Building Permit Application

Permit No.: B17002743

RE: B17002743
14051 Tall Ships Drive
West friendship, MD 21794

This letter is in response to building permit **B17002743**. The application describes SFD/ 1-STORY ADDITION - MASTER BEDROOM & BATH ON FIRST FLOOR/ APPROX - 35X24. Since a living space addition is being proposed on a property with a private well & private sewage disposal system, this triggers the requirement to evaluate the existing septic record and the adequacy of both well and septic system components.

MAIN FLOOR PLAN

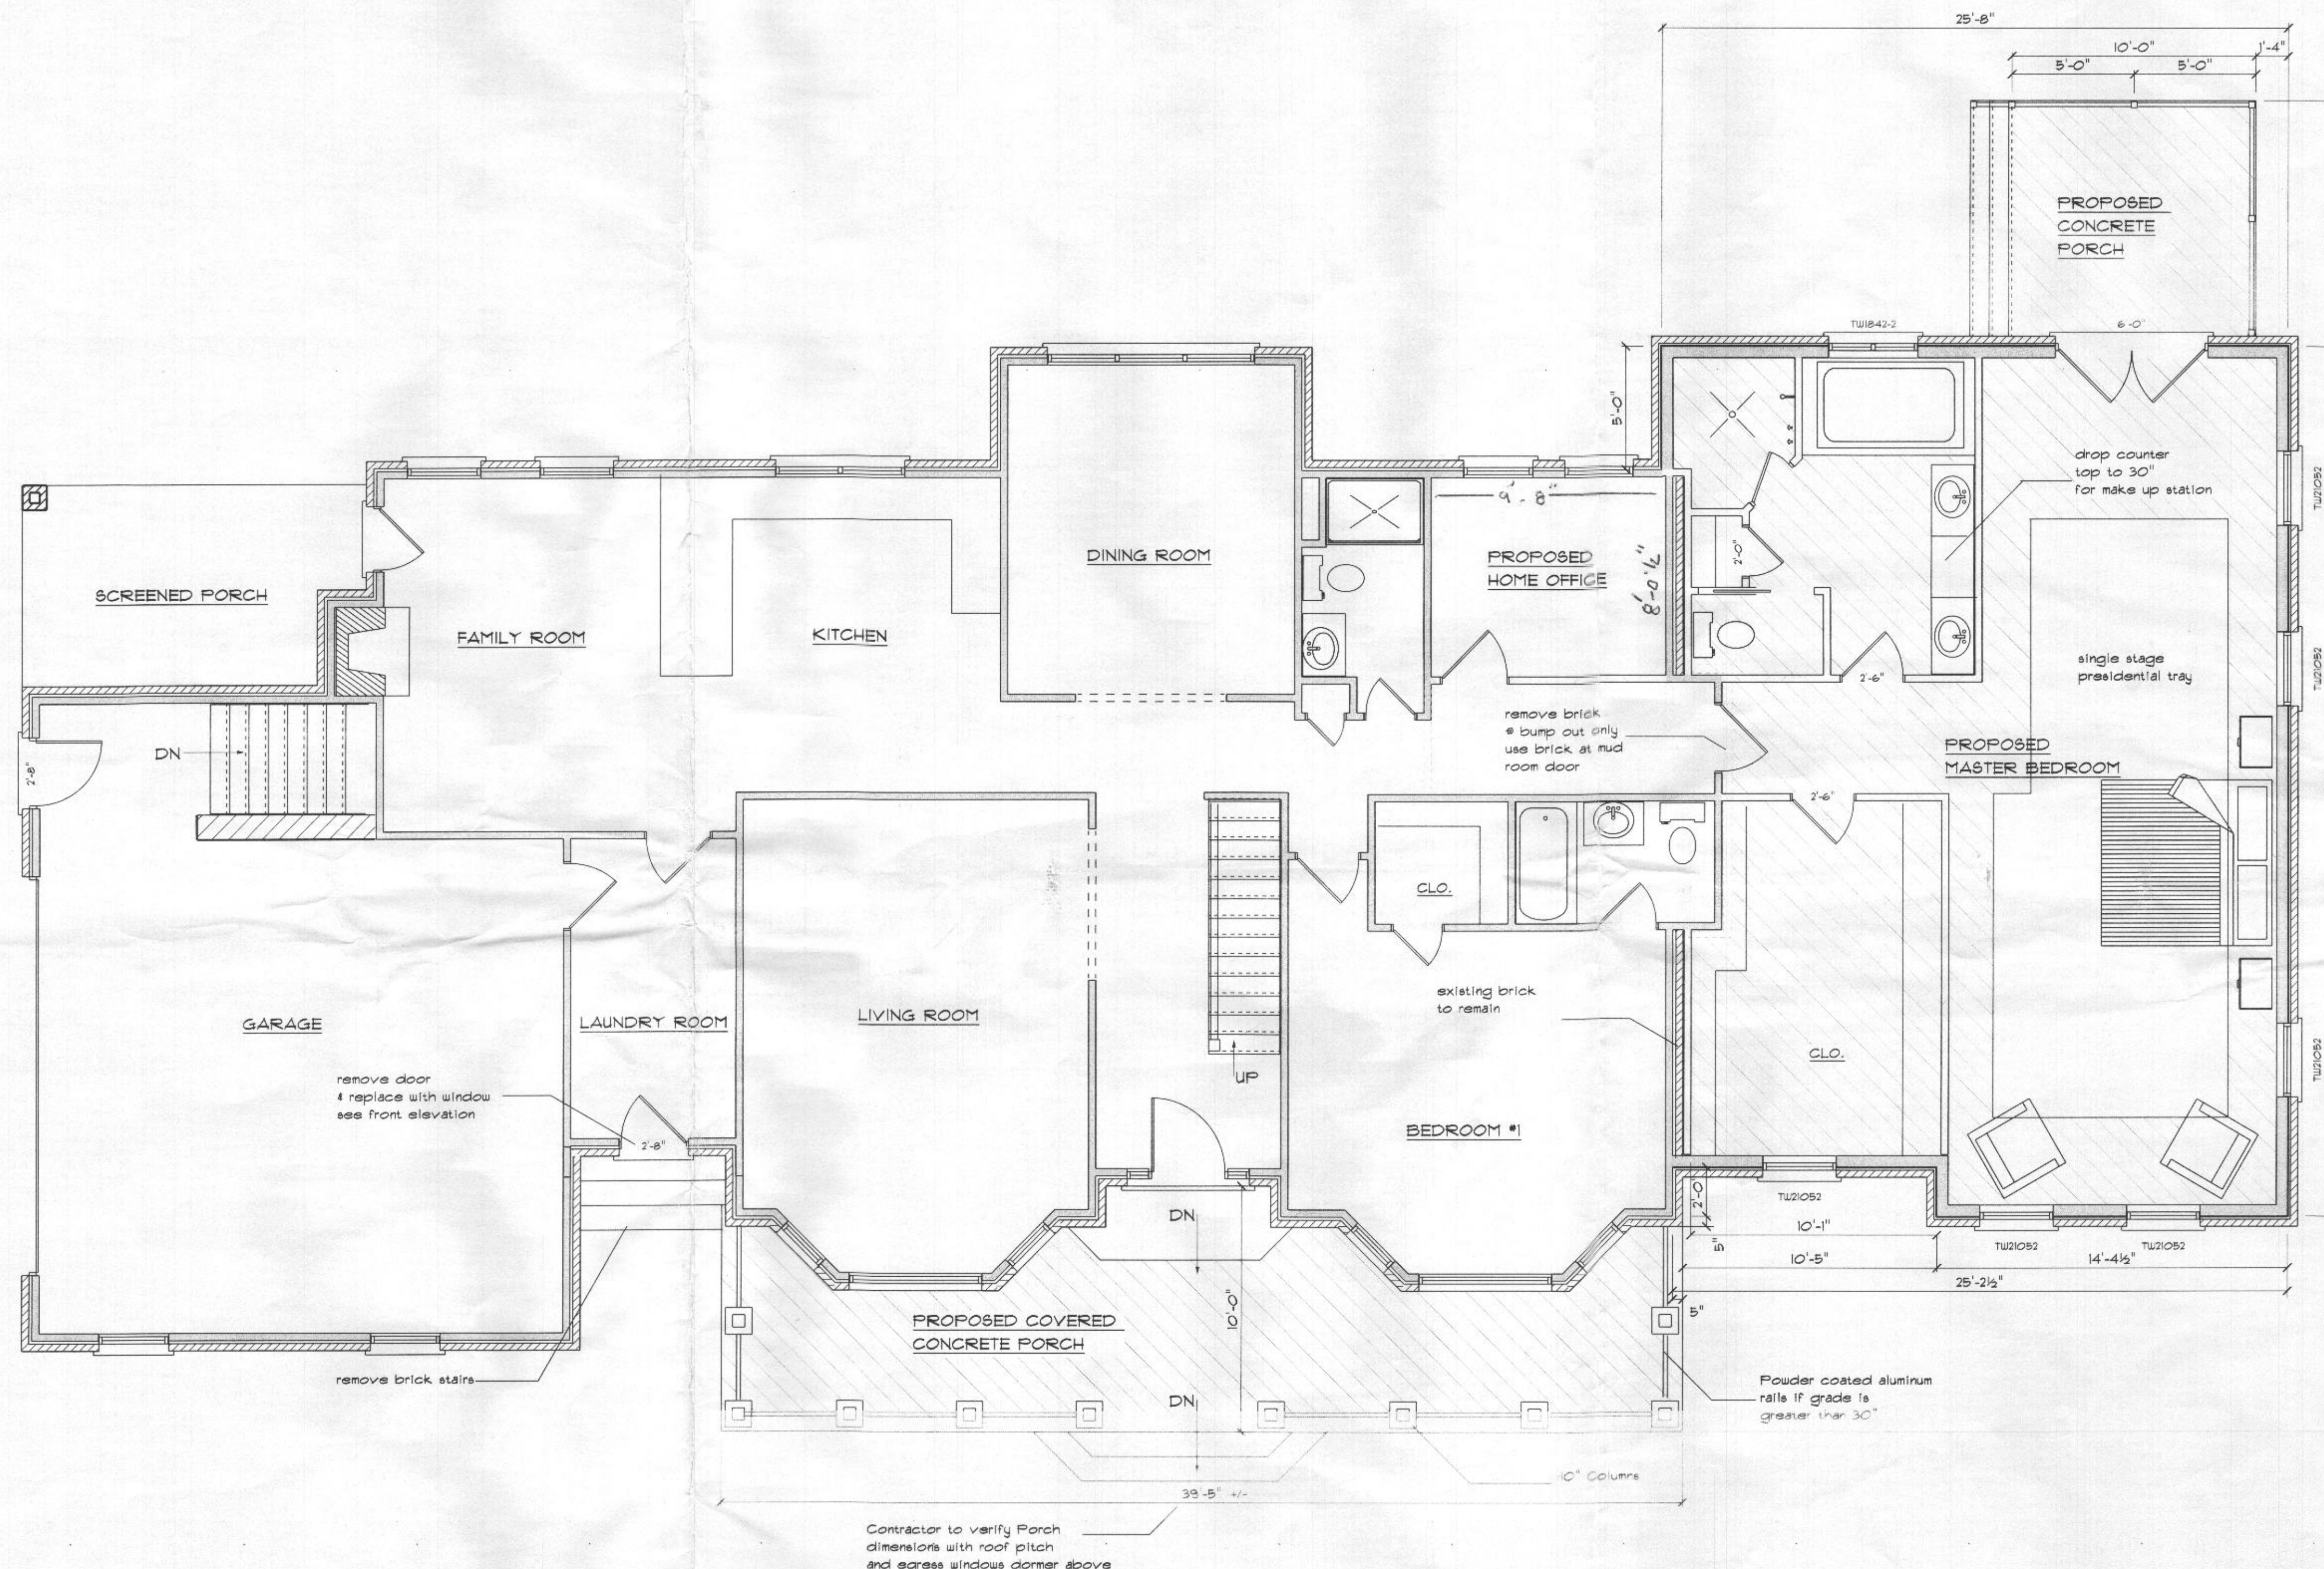
I believe you came into our office last week to discuss your proposed addition. I just received the main floor plan from building permits office for the proposed master bedroom addition but the plan did not include the dimensions of the proposed home office like we discussed. In addition, the plan did not include the existing floor plan layout for the basement and second floor. These plans are required by the Health Department in order to assess the total number of bedrooms within the residence.

Good morning. Thank you for your follow-up call. Please see attached letter and email dated July 28 and September 22, 2017. I still need a set of floor plans for the existing house and dimensions of the proposed home office in order to determine the number of total bedrooms for the residence. In addition, the site plan must be revised to show the well and septic system components meeting the required setbacks.

Thanks for the clarification on the floor plans. The proposed office does not meet the minimum dimensions so it won't be considered a bedroom. However, you are still increasing bedrooms from 3 to 4 so the septic tank will need to be upgraded prior to BP approval. In addition, the building permit site plan will need to be revised because it does not match the As Built drawing (i.e. well locations are different and it does not include the septic system components (i.e. septic tank and trenches) or the proposed concrete porch.
